Vogle Project

August 1, 1988

PLANT VOGTLE - UNITS 1 & 2
NRC DOCKETS 50-424, 50-425
OPERATING LICENSE NPF-68, CONSTRUCTION PERMIT CPPR-109
FSAR CHANGES FOR RADWASTE FACILITIES

Attached are the proposed changes to the FSAR for the Dry Active Waste (DAW) Facilities, Alternate Radwaste Building (ARB), Control Area modification, and the ARB bridge crane addition. Existing warehouses located on the southwest portion of the owner controlled area are being extensively modified to handle the DAW. A new addition to the ARB will house the ARB Control Room and dress-out area. The existing pedestal crane in the ARB is being replaced by a bridge crane.

FIGURE 9A-44

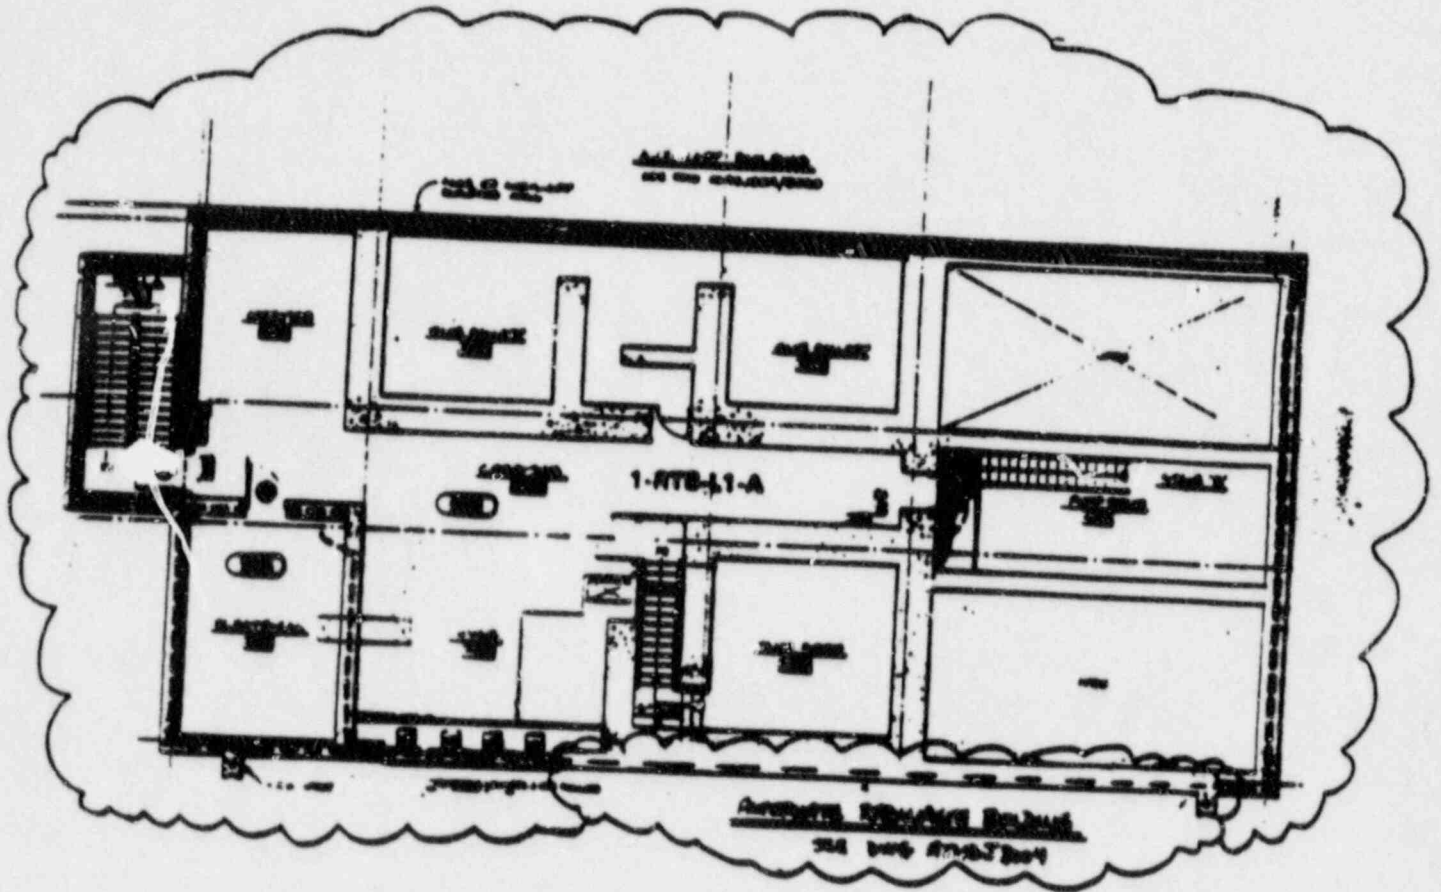
PROPOSED CHANGES

DRY ACTIVE WASTE
 PROCESSING BUILDING
 FIGURE 12.3.1-1 (sheet 42)
 (ref. dwg. AS1065A14-1)
 New FSAR Fig

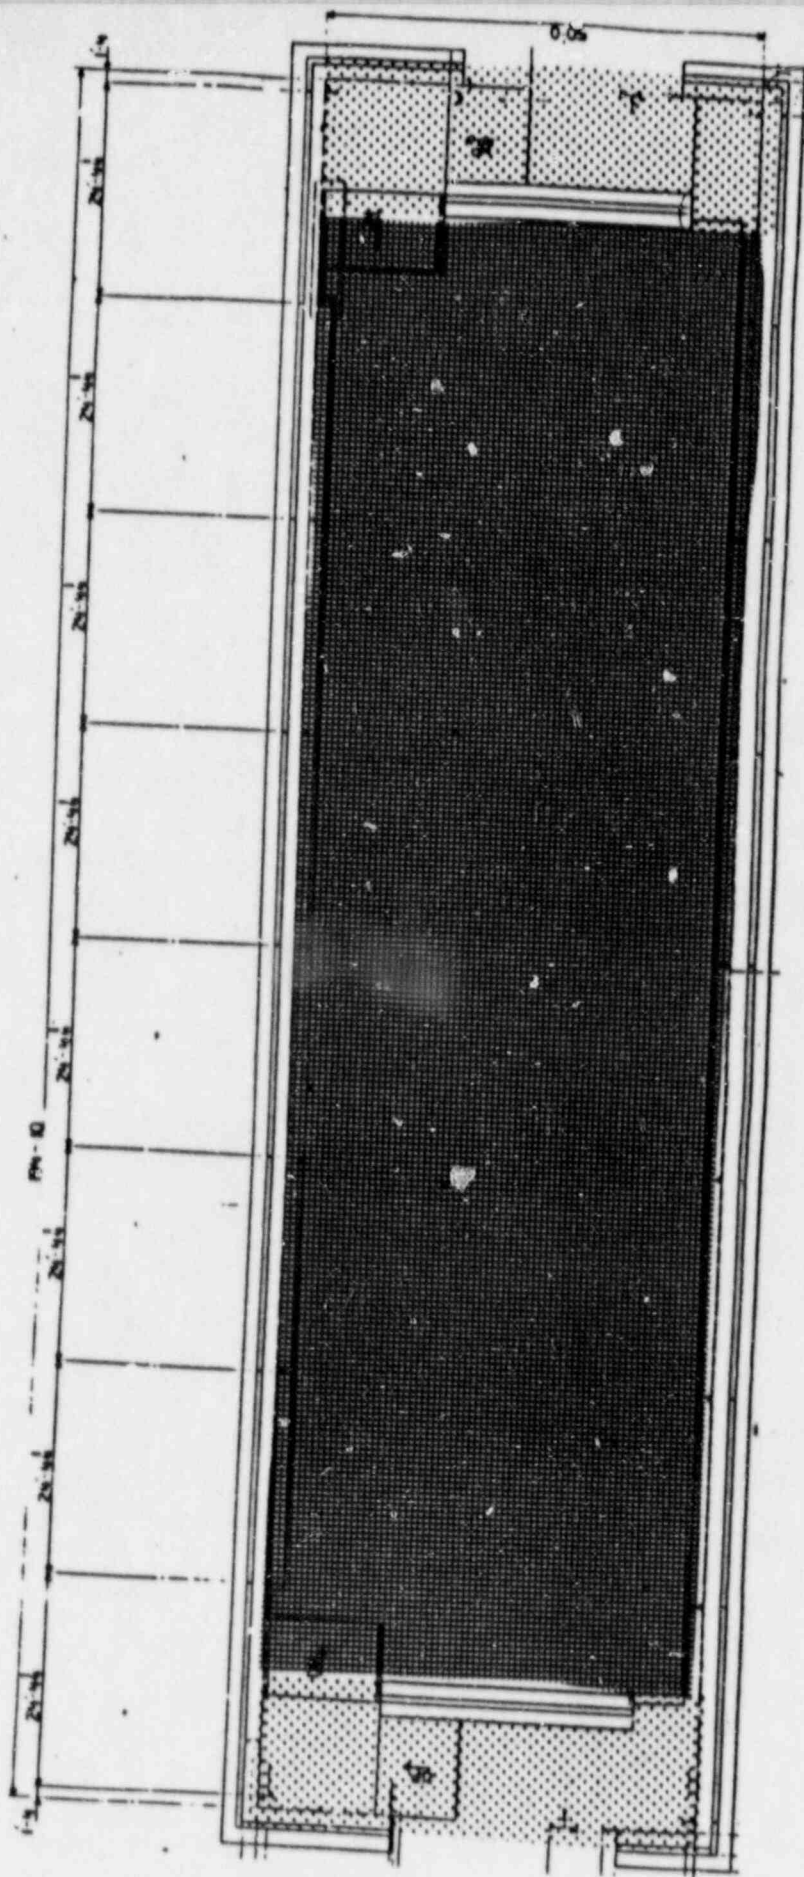
(Add to FSAR Figure 12.3.1-1 (shd 35 of 41))

DRY ACTIVE WASTE
 PROCESSING BUILDING
 FIGURE 12.3.1-3 (sheet 34)
 (ref. dup. AX1065A14-1)

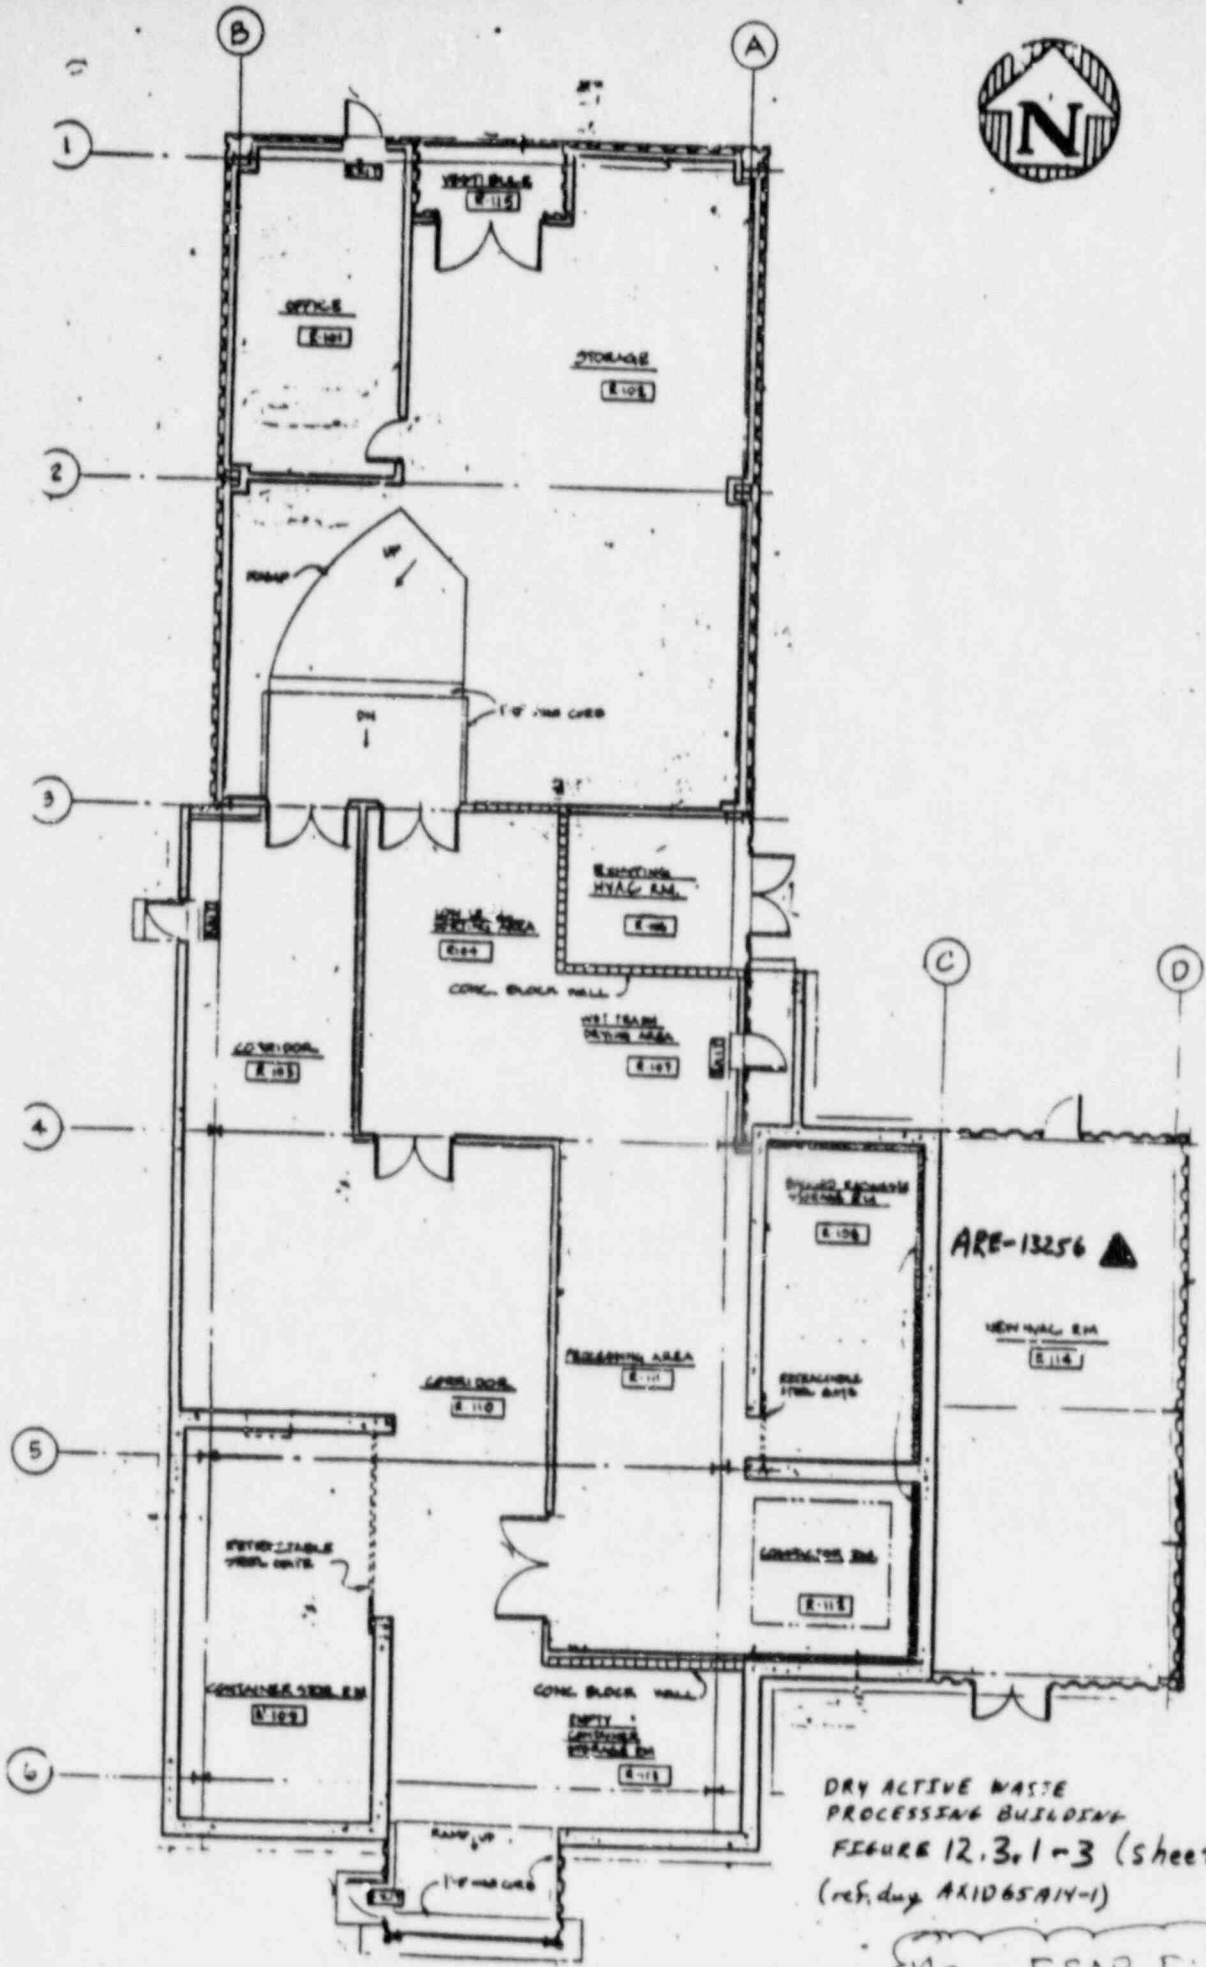
New FSAR Fig

Figure 12.3.1-3 (Sheet 35 of 35)

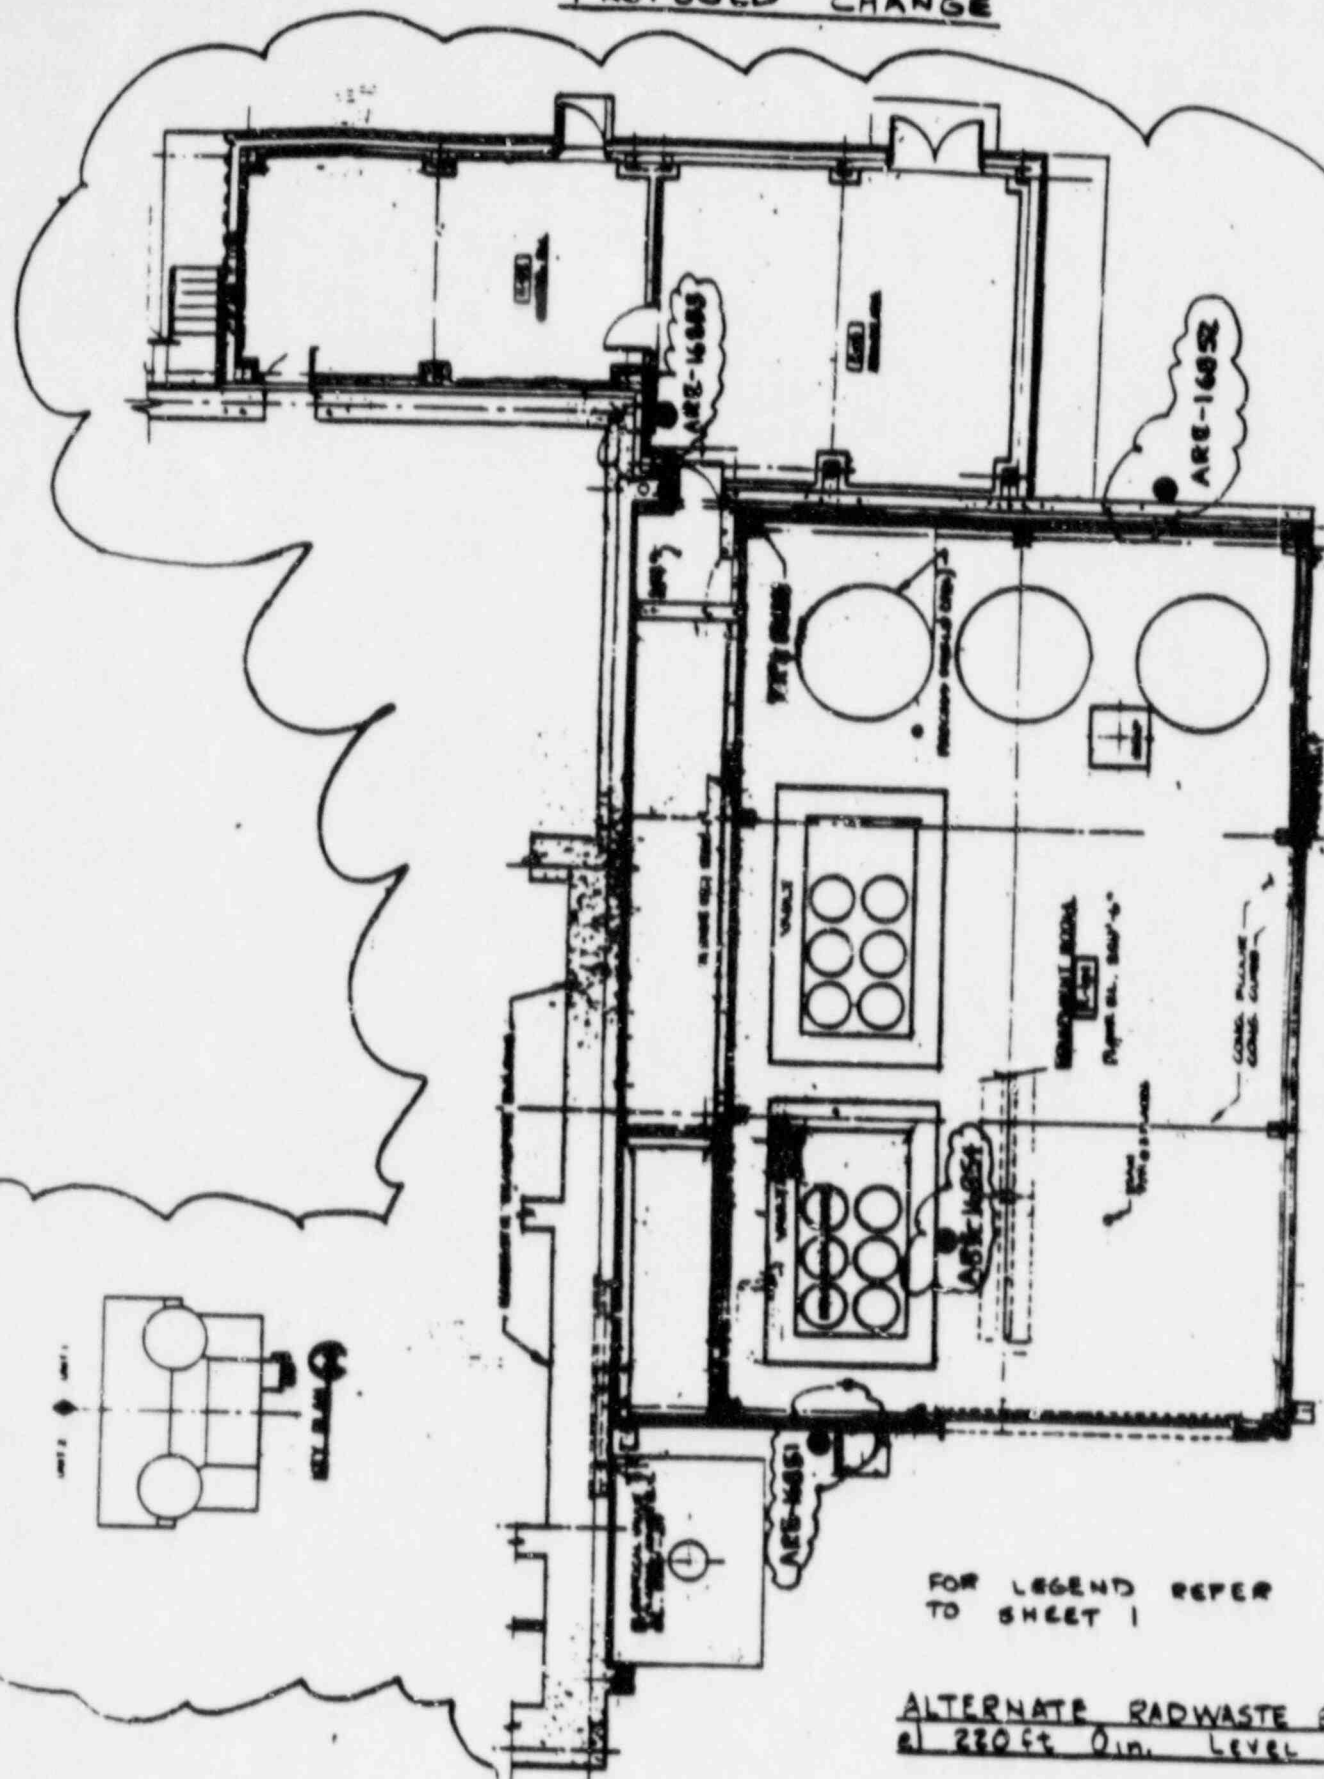
PROPOSED CHANGE
